AMENDMENTS TO THE DRAWINGS

Attached hereto are two (2) sheets of corrected formal drawings that comply with the provisions of 37 C.F.R. § 1.84. The corrected formal drawings incorporate the following drawing changes:

FIG. 22
PRIOR ART

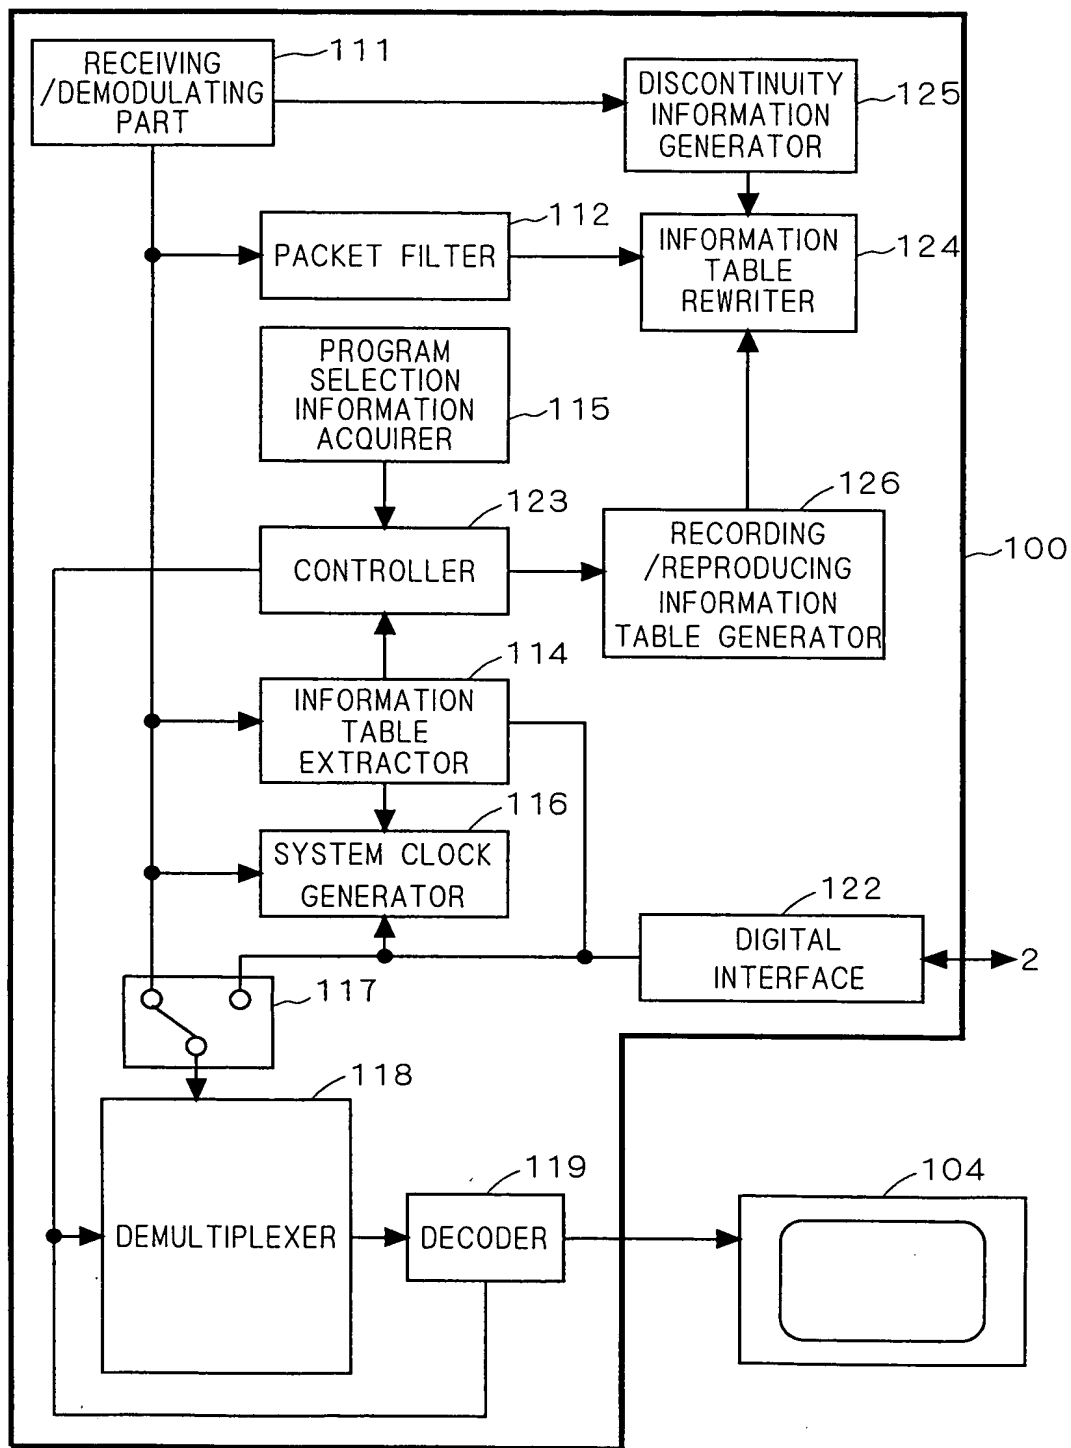
In compliance of the Examiner's objection, Figs. 22 and 23 have been labeled with a legend "Prior Art" indicating the conventional status of the technology shown therein. In addition, a typographical error has been corrected in element 122. Specifically, "digitral interface" has been corrected as "digital interface". Furthermore, switch element 117 has been appropriately labeled in Fig. 22. There are no other changes to these drawings.
